| Document Title: | Staff Memo – Revisions to 2025 Energy Code, Section 1404(a)3 - Variable Air Volume with AWHP and Parallel Fan-Powered Boxes |

SUBJECT: Justification for CEC-proposed Revisions to 2025 Energy Code, Section 140.4(a)3Aiii on Multi-zone Space-conditioning System Types to Support the August 15-day Comment Period – Variable Air Volume with Air-to-Water Heat Pump and Parallel Fan-Powered Boxes

DATE: AUGUST 22, 2024

Figure 1: Large Office LSC Savings for the Revised VAV+AWHP, PFPB compared to the 2022 Standard Design

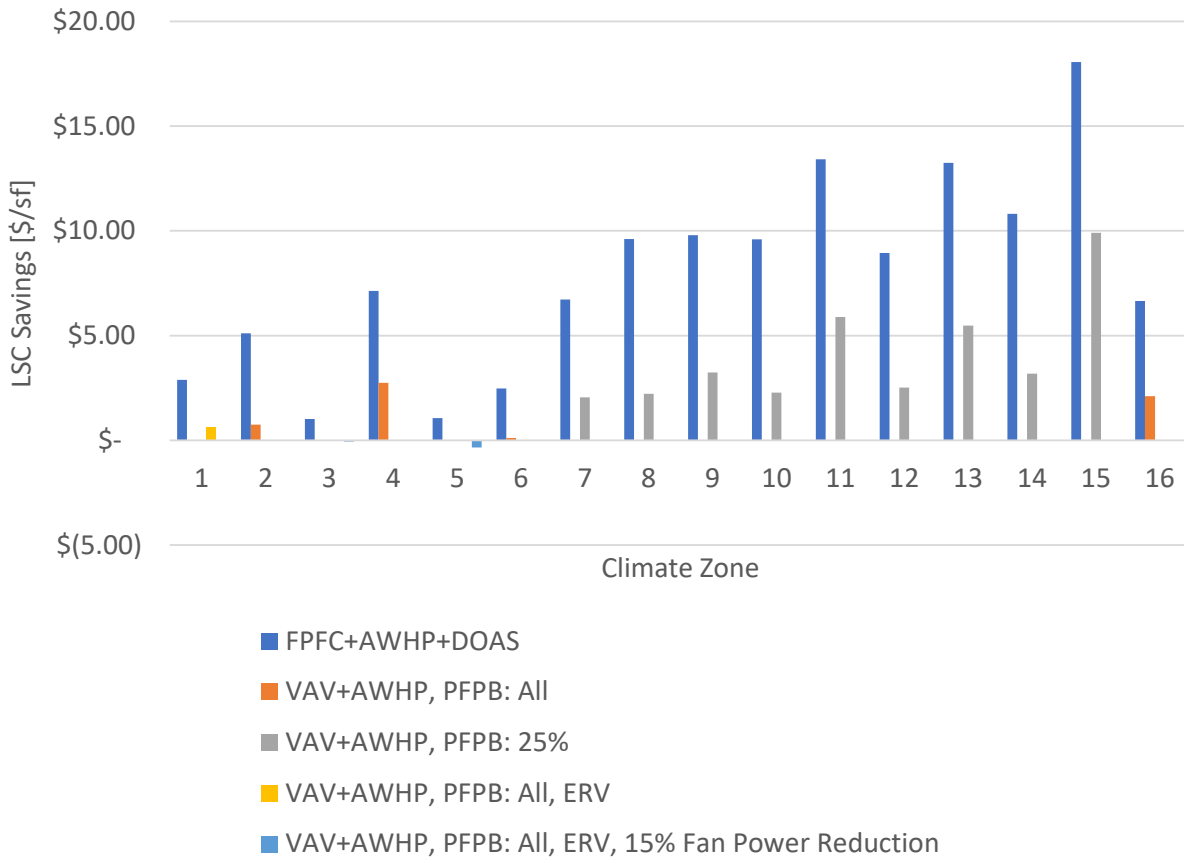
Figure 1 presents the Large Office LSC savings results of the revised VAV+AWHP, PFPB system compared to the 2022 standard design. Requiring PFPBs on all orientations was necessary to achieve enough LSC savings for climate zones 1 through 6 and 16. Additional measures, detailed above, were needed for climate zones 1, 3, and 5. Climate zone 16 with 25% PFPBs for only 25% of perimeter zone heat capacity achieved LSC savings but resulted in a high number of hours where the thermostat setpoint could not be maintained. Requiring PFPBs for all orientations in climate zone 16, reduced the number of hours where the thermostat setpoint could not be maintained to a reasonable level. Requiring PFPBs on all orientations for climate zones 7 through 15 was determined to not be needed to achieve LSC savings. So, requiring PFPBs for only 25% of perimeter zone heat capacity was deemed sufficient for these climate zones. These system configurations for the revised VAV+AWHP, PFPB system are being proposed instead of the FPFC+AWHP+DOAS system to establish the 2025 Energy Code standard design. It is anticipated that this standard design will offer more flexibility and provide a more achievable energy budget for other HVAC designs that leverage heat pumps, including those that could be prescriptively allowed through the Executive Director approval path as provided in Section 140.4(a)3Av of the August 2024 Express Terms.

Figure 2: Large Office Source Energy Savings for the Revised VAV+AWHP, PFPB compared to the 2022 Standard Design

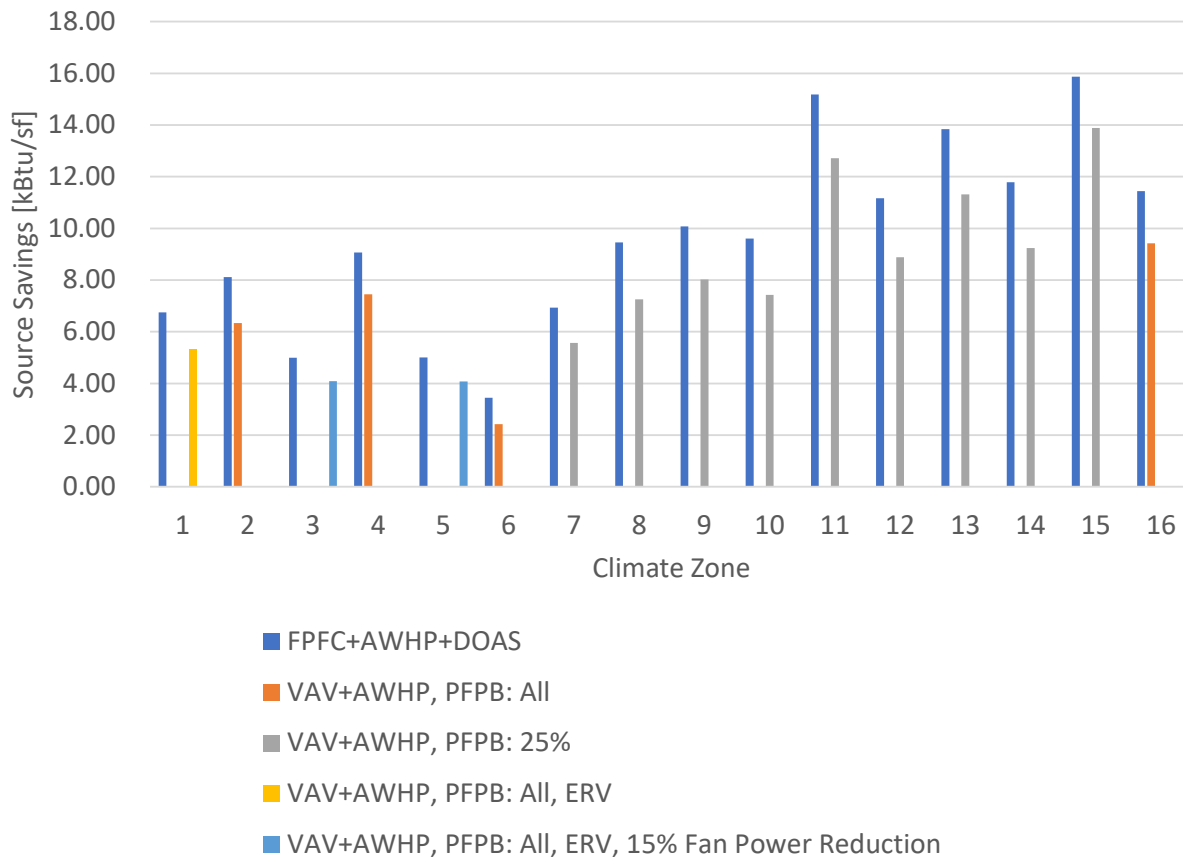
Figure 2 presents the Large Office Source Energy savings results of the revised VAV+AWHP, PFPB system compared to the 2022 standard design. This figure shows that although the LSC savings are reduced with the revised VAV+AWHP, PFPB, there remain Source Energy savings compared to the 2022 standard design.

Figure 3: Large School LSC Savings for the Revised VAV+AWHP, PFPB compared to the 2022 Standard Design

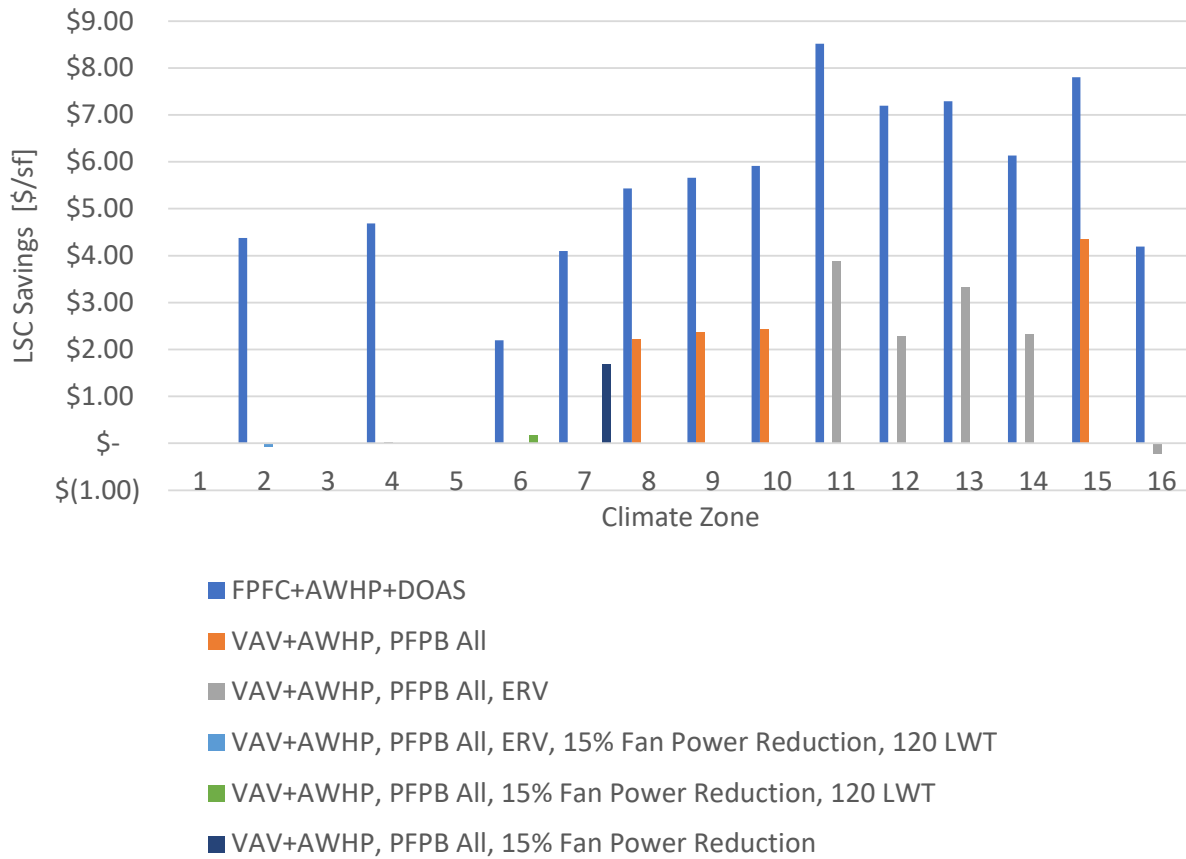
Figure 3 presents the Large School LSC savings results of the revised VAV+AWHP, PFPB system compared to the 2022 standard design. Because there are no solutions that achieve LSC savings in climate zones 1, 3, and 5, no results are shown in Figure 3 for those climate zones. Combined with the measures described, the revised VAV+AWHP, PFPB system achieved approximately the same LSC savings in climate zones 2, 4, and 11 through 16. Climate zones 6 through 10 had LSC savings

but less than the FPMC+AWHP+DOAS system. Like the Large Office, these system configurations for the Large School prototype are anticipated to provide more flexibility and provide a more achievable energy budget for other HVAC designs that leverage heat pumps, including those that could be prescriptively allowed through the Executive Director approval path as provided in Section 140.4(a)3Av of the August 2024 Express Terms.

Figure 3: Large School Source Energy Savings for the Revised VAV+AWHP, PFPB compared to the 2022 Standard Design

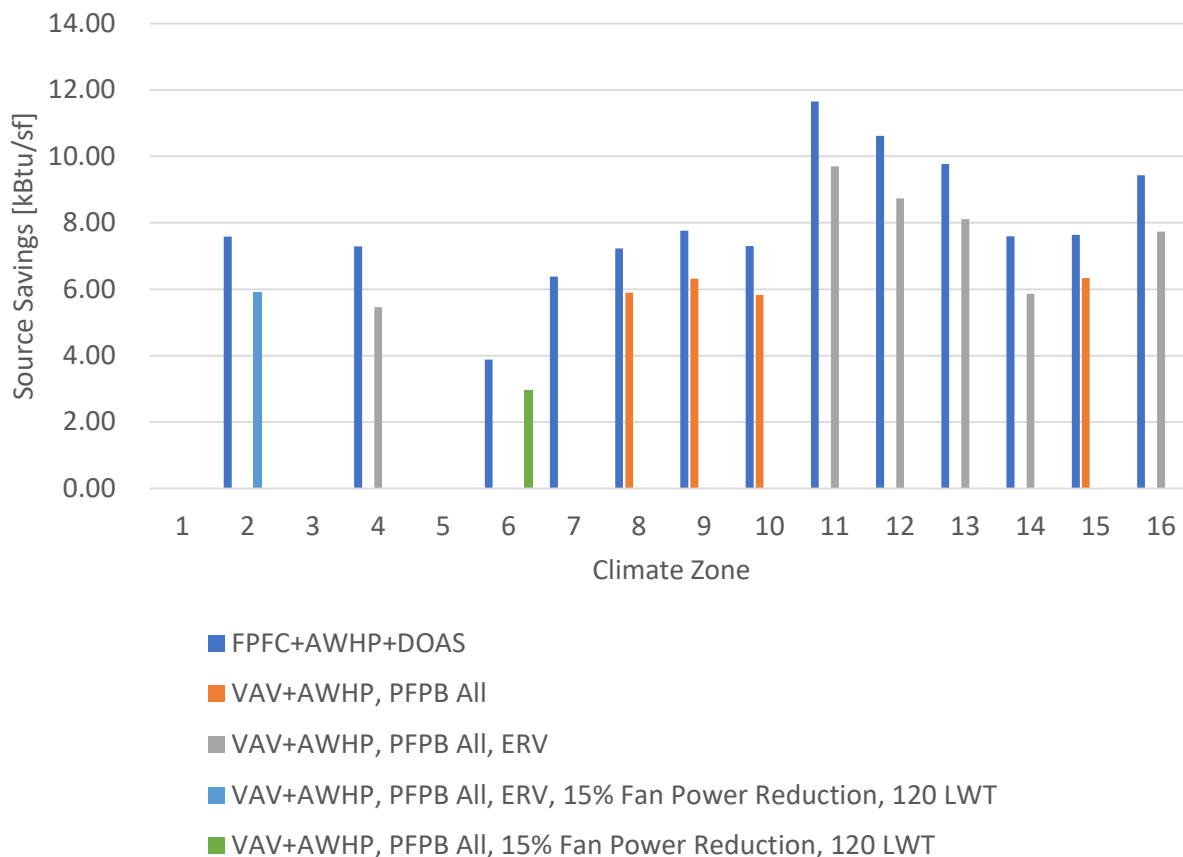
Figure 4 presents the Large School Source Energy savings results of the revised VAV+AWHP, PFPB system compared to the 2022 standard design. Like the Large Office, this figure shows that LSC savings are reduced with the revised VAV+AWHP, PFPB.
